STERLING RANCH ROAD & BRIARGATE PARKWAY STORM PLANS

STORM SEWER PLANS

PCF FILING NO.: CDR 221

v4_CDs Storm.pdf Markup Summary

STERLING RANCH ROAD & BRIARGATE PARKWAY STORM PLANS
COVER SHEET

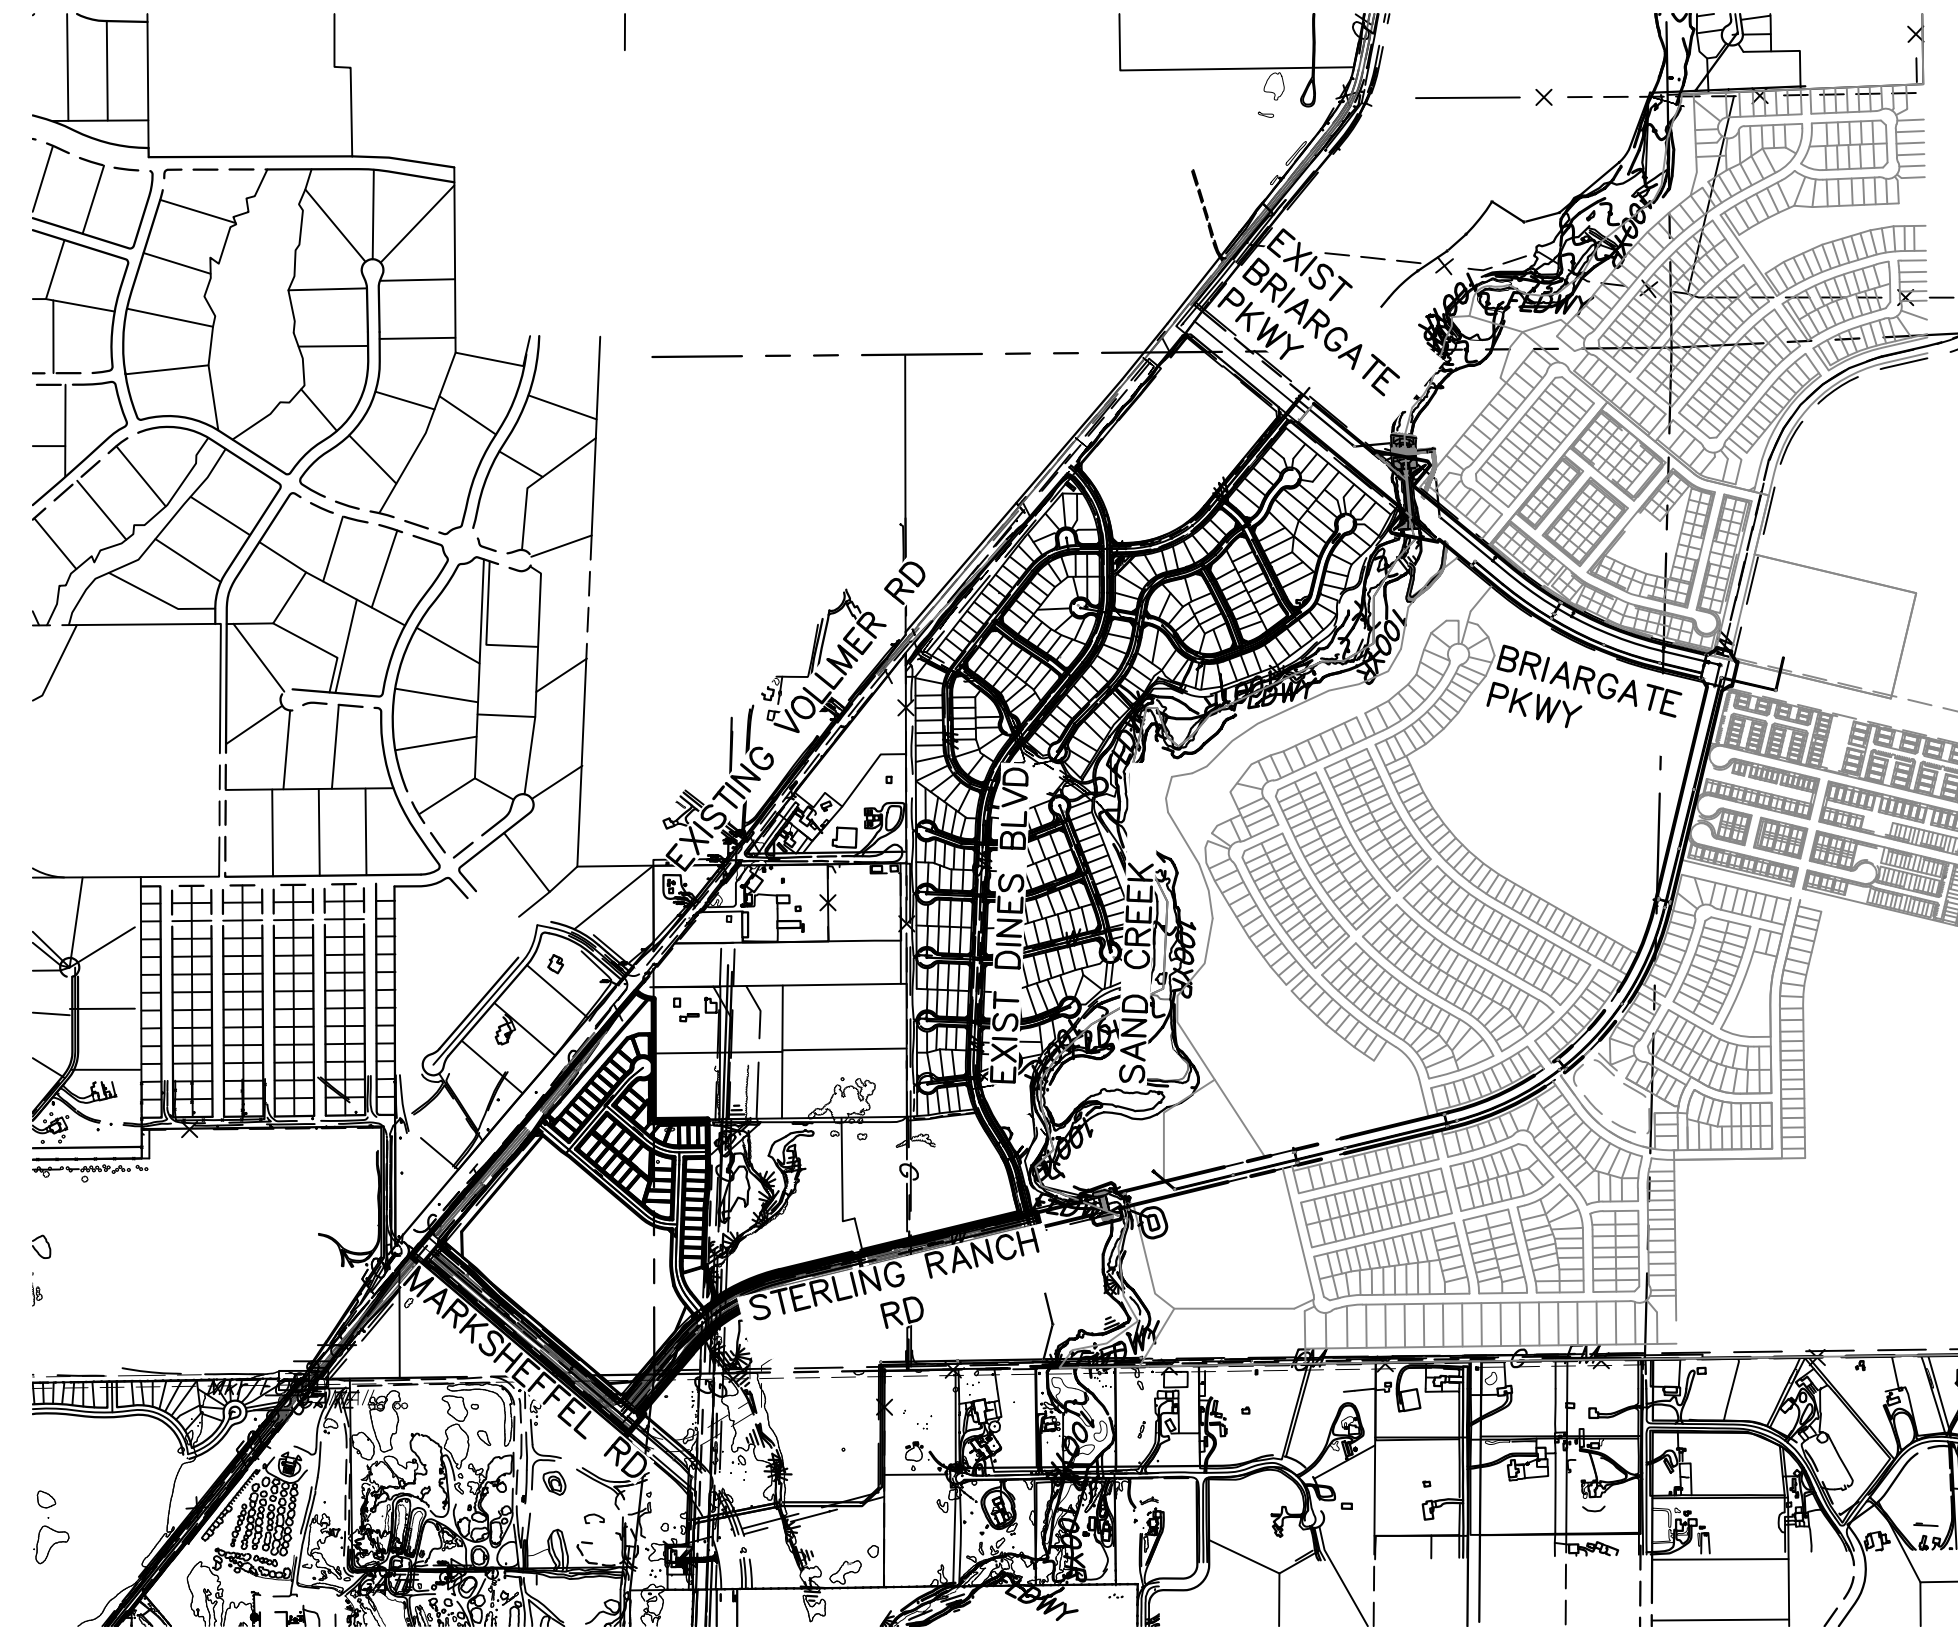
Remove interim

DP12 PROFILE (1)
STA 10+00.00 TO 17+00.00
 PUBLIC

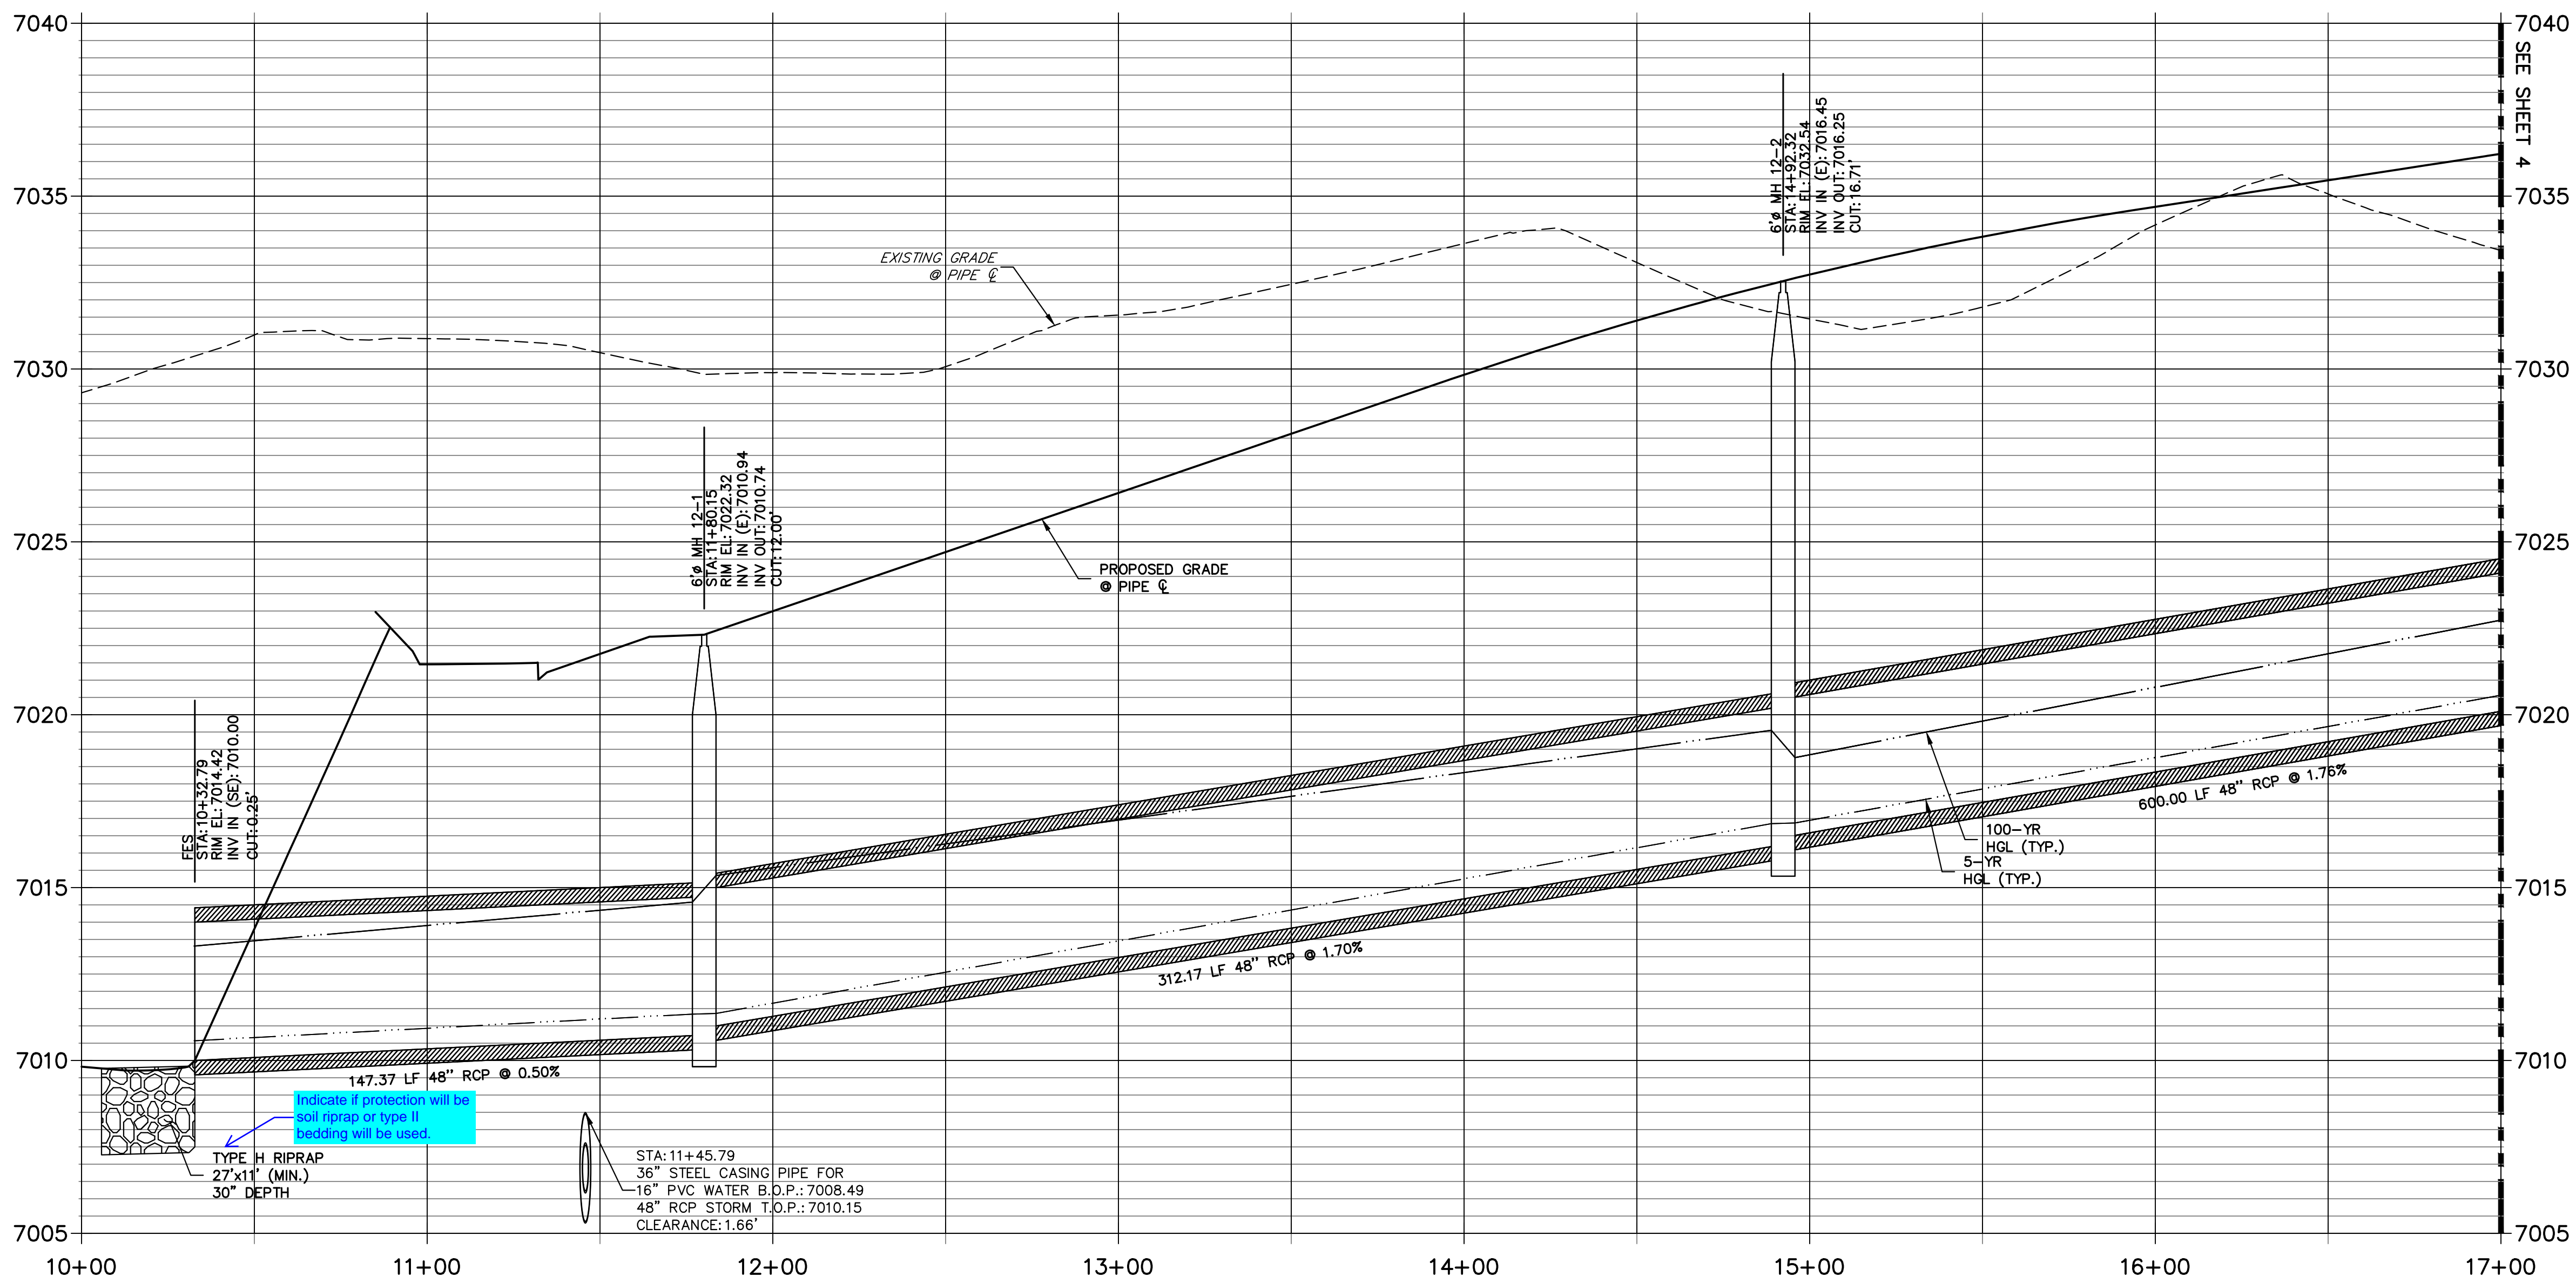
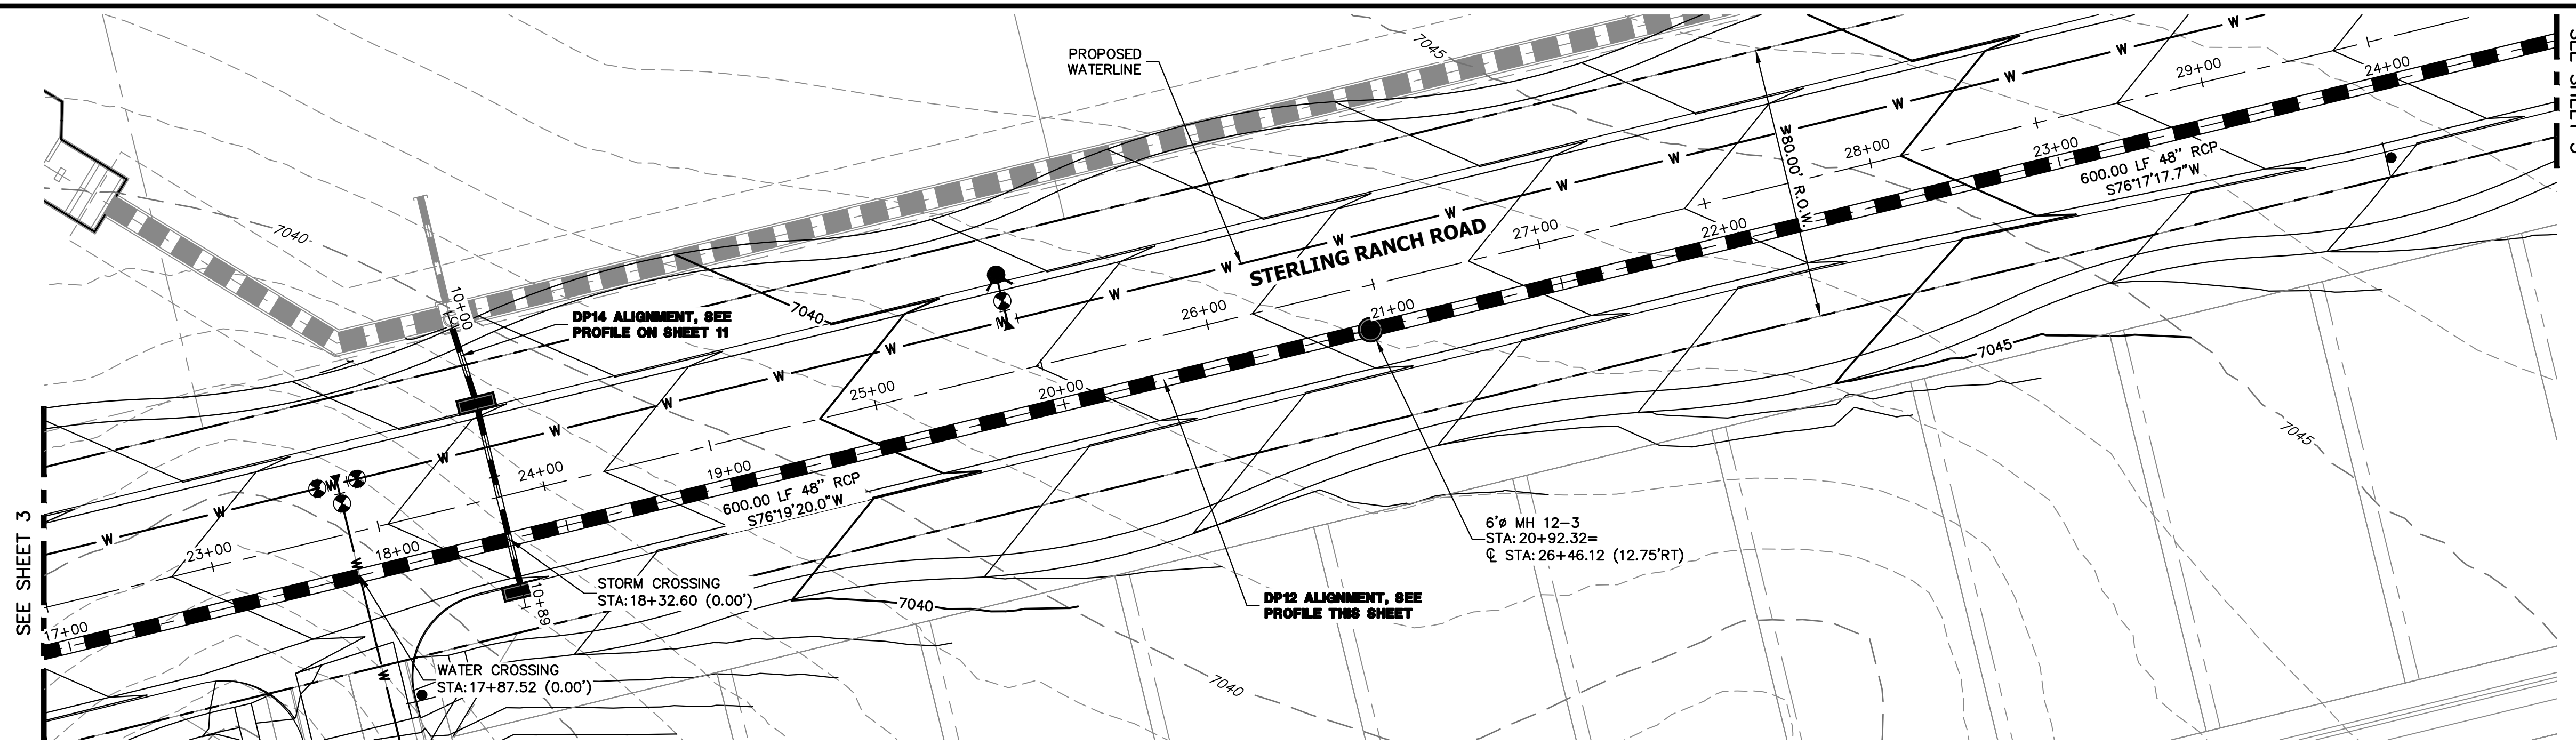
Indicate if protection will be soil riprap or type II bedding will be used.
